Nassa Spinners and Garments Ltd.

Plot No.- 197-200, Comilla EPZ, Comilla.
Co-ordinates: 23.449240N, 91.185205E
25th July 2019

ACCORD
on Fire and Building Safety in Bangladesh

Observation : Main Production Shed

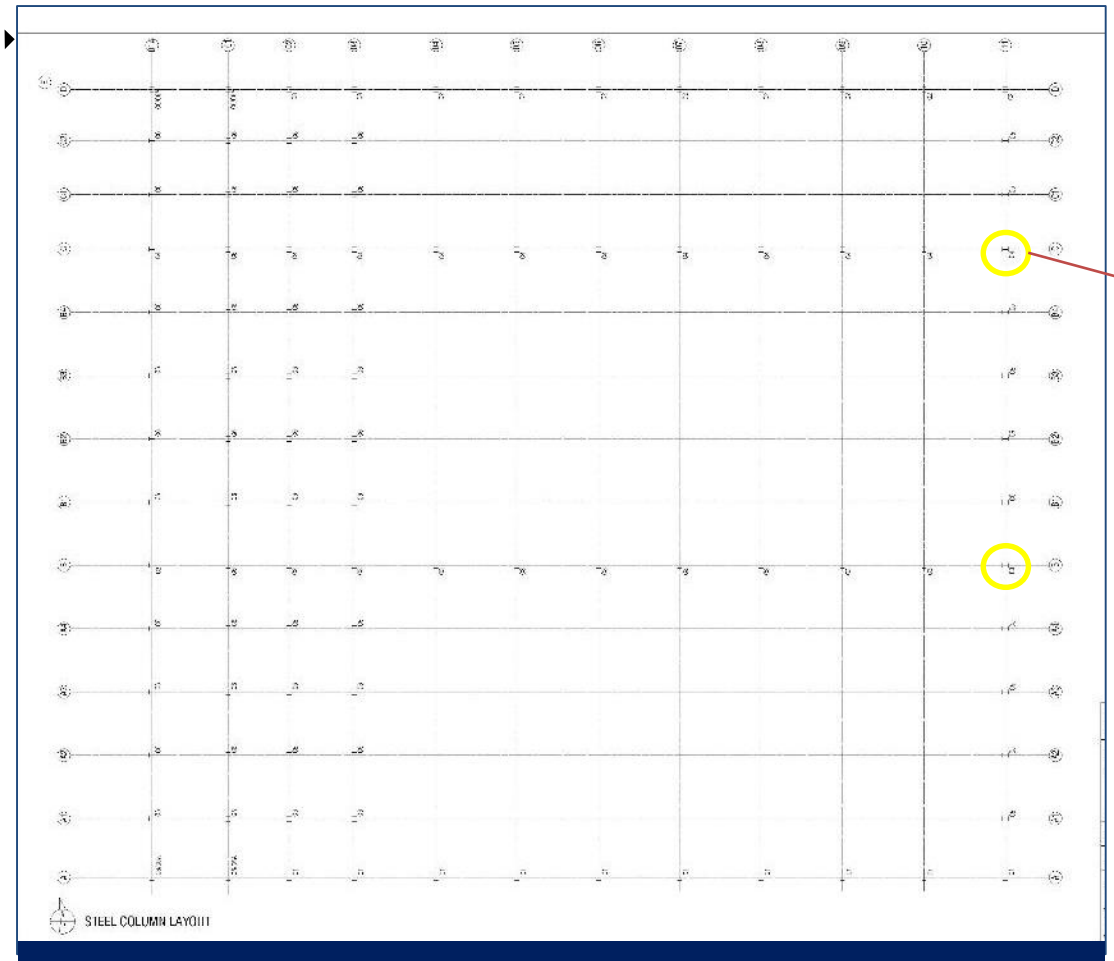
Faulty connection

Number of bolts required to verify

Bolt and welded connection

Bolt hole excessive larger than the bolt diameter

Significant gap in connection

Welded connection in place of bolted connection

Building engineer is required to investigate the connections and prepare an adequacy report.

Steel column layout plan

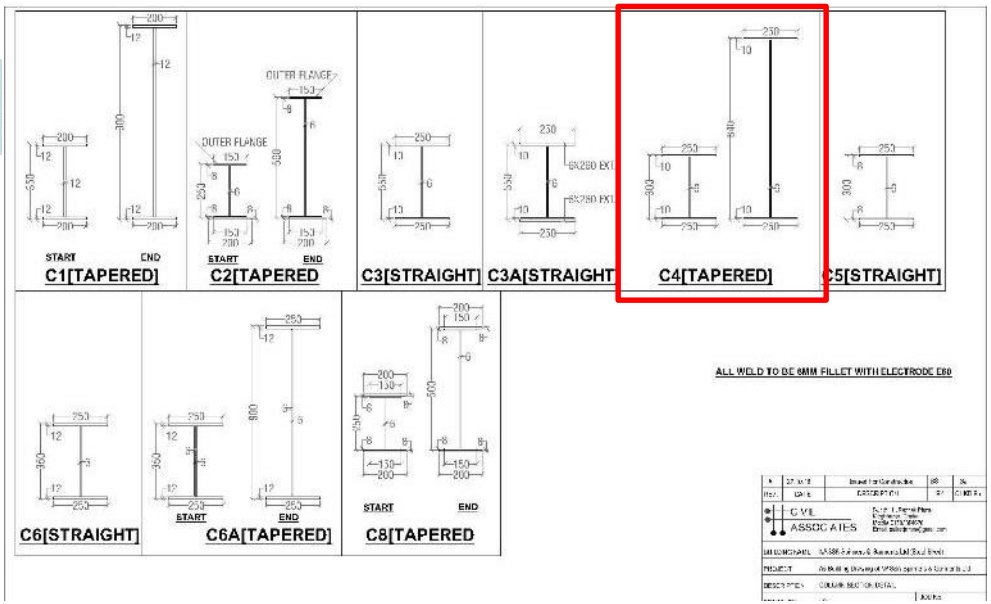
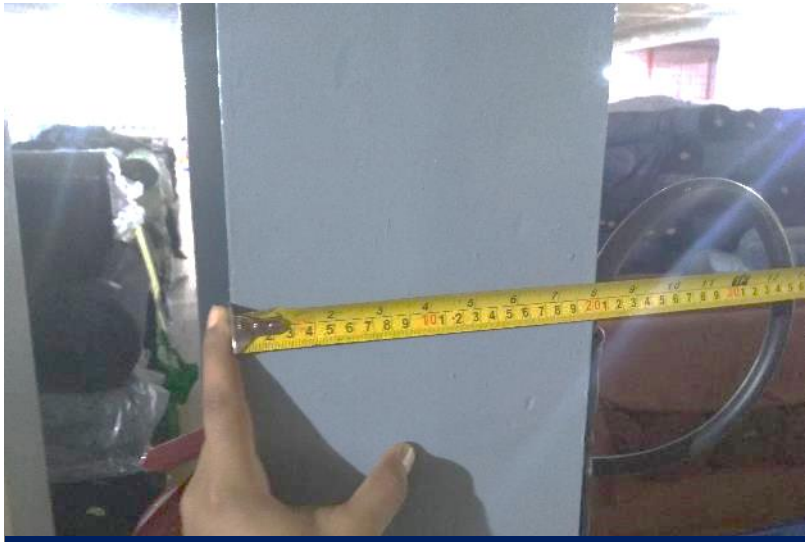
Discrepancies in drawings

Orientation of this columns not matched.

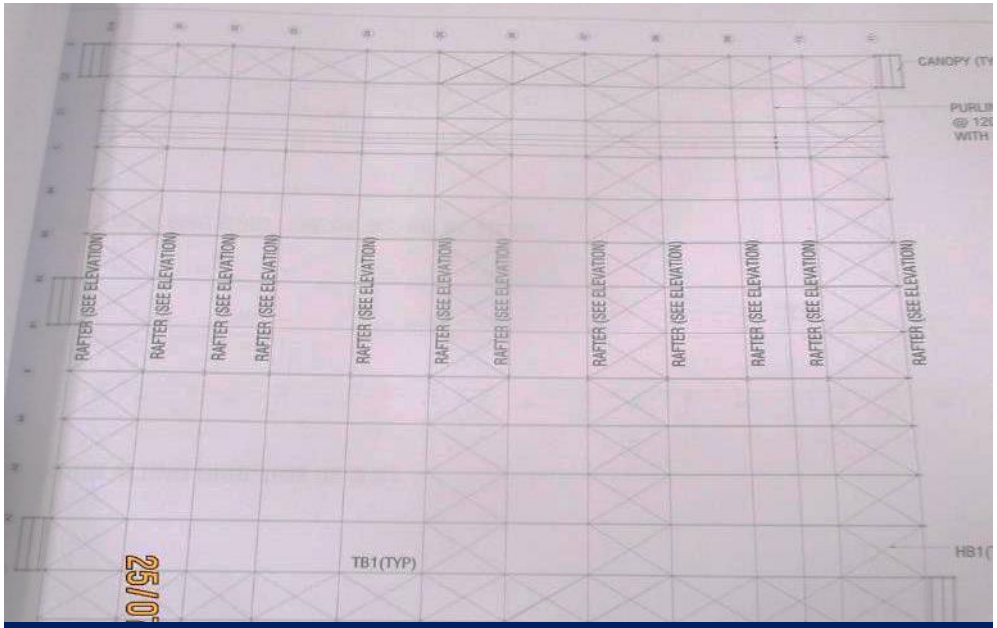
C4 column flange width measured 200 mm instead of 250 mm

Grade slab details not incorporated in drawings

Compression strut detailing not available.

Damage in beam, column & bracing

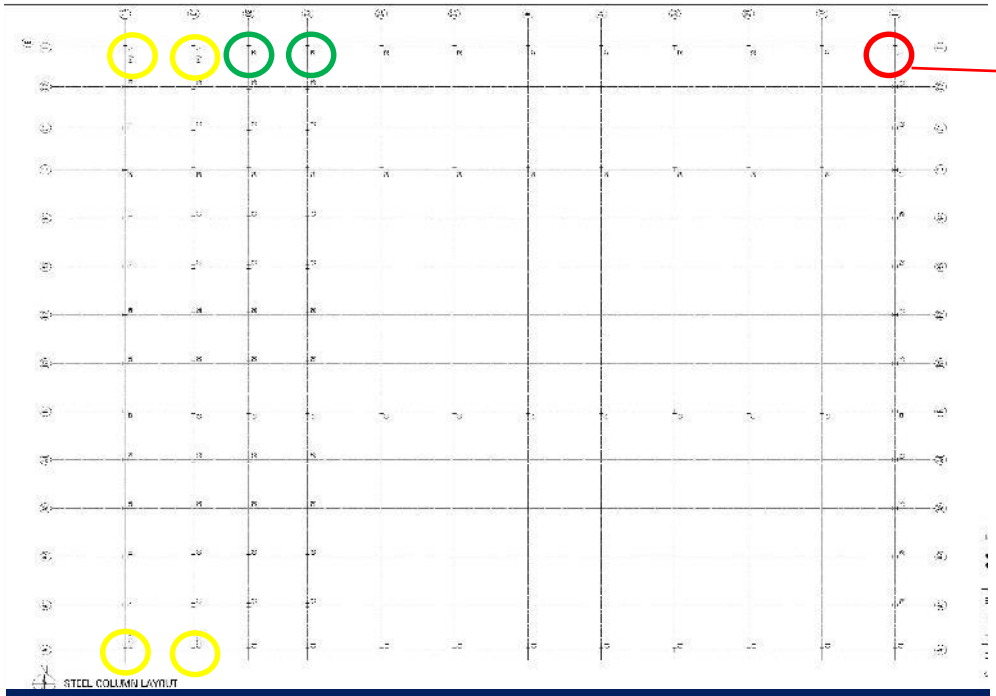
Damaged column

Damaged bracing

Damaged beam

Damage in beam, column & bracing observed in several locations. Building engineer is required to implement remedial action based on assessment report.
